Access Compliance Report

Public Rights-of-Way

Intersection ID: 44020	Main Street: ENOCH_DR	Cross Street: OAK_PASTURE_LN	Location: SW
ADA ID: B785ACAA4185	Ramp Type: Perp	Initial Pass/Fail: Fail	Overall Compliance: No
Severity Score: 58.75			
Codes/Mitigation Info/Possible Solution		Field Measurements/Component Compliance

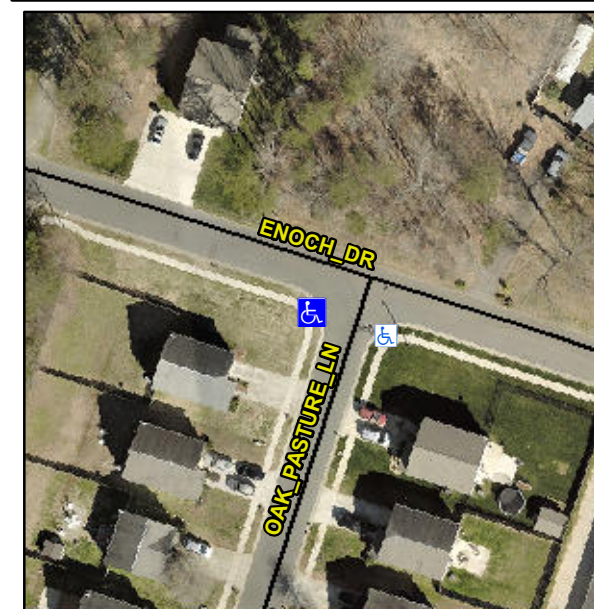
Not Found, R304.5.1, R304.2.2, R304.5.3

Compliance	Description	Data	Compliance	Description	Data
N/A	Ramp Length (in)	46.0	No	Ramp Slope (%)	12.7
No	Ramp Width (in)	37.0	No	Ramp XSlope (%)	8.4
N/A	Flare Type LT	N/A	N/A	Flare Type RT	N/A
N/A	Flare Slope LT (%)	N/A	N/A	Flare Slope RT (%)	N/A
N/A	Flare Traversable LT?	N/A	N/A	Flare Traversable RT?	N/A
N/A	Landing Length (in)	N/A	N/A	DWS Provided?	N/A
N/A	Landing Width (in)	N/A	N/A	DWS Contrast?	N/A
N/A	Landing Slope (%)	N/A	N/A	DWS Length (in)	N/A
N/A	Landing X Slope (%)	N/A	N/A	DWS Full Width?	N/A
N/A	Landing Curb? (Y/N)	N/A	N/A	DWS Offset (in)	N/A
N/A	Shared Landing?	N/A			
N/A	Gutter Ponding?	N/A	N/A	Gutter Slope (%)	N/A
N/A	Gutter Lip Ht (in)	N/A	N/A	Gutter X Slope (%)	N/A
N/A	Painted X Walk1?	No	N/A	Painted X Walk2?	N/A
	X Walk 1 Direction	To SE		X Walk 2 Direction	N/A
N/A	X Walk 1 Width (in)	N/A	N/A	X Walk 2 Width (in)	N/A
	X Walk 1 Slope (%)	1.9		X Walk 2 Slope (%)	N/A
	X Walk 1 X Slope (%)	4.1		X Walk 2 X Slope (%)	N/A

Remove & Replace Entire Ramp.
